SERVICEORDRE – 2011-4

HENVISNING:	Icarus Servicebulletine # 2011001, 27 juli 2011
FORMÅL:	Bytte av C1 line på NEOS
STATUS:	Obligatorisk
IDENTIFIKASJON:	Alle NEOS skjermes P/N 317524-XXX med serienr lavere enn 24112612 og alle størrelser.
BAKGRUNN:	Det har vært et økende antall klager på sporadiske harde åpninger. Icarus har gjennomført lange og mange tester før de fant ut av problemet og fikk utviklet et tiltak mot dette. (For detaljert beskrivelse se side 1 i produsentens SO)
SERVICE:	C1 linen skal byttes iht den vedlagte tekniske manualen fra produsenten.
UTFØRELSE:	<p>Før neste hopp. Byttet av C1 lina utføres av MK/MR og det skal foretas kontroll av at C1 lina er festet ytterst på quick- eller softlinken (se tech ordre fig 14). Etter byttet skal vedlagte kontrollmal (side 3 i produsentens SO) fylles ut og sendes til icarusorders.eu@icaruscanopies.aero Skjermens advarsels "etikett" skal merkes med C1 når utført (se Tech ordre fig 17) Når alt dette er utført, påføres riggens kontrollkort SO 2011-4 byttet C1line ok.</p> <p>Modifiseringskitet kan bestilles gjennom Icarusforhandler. Ved bestilling skal skjermstørrelse og serienummer oppgis. Icarus opplyser at det er omkring to ukers

Fig. 1. Distribution of the lines in the Neos canopy.

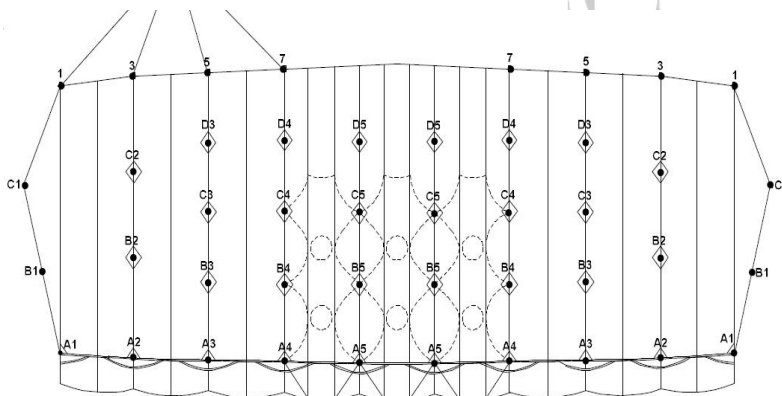
Purpose: To provide detailed instructions describing how to replace the C1 lines on NEOS canopies.
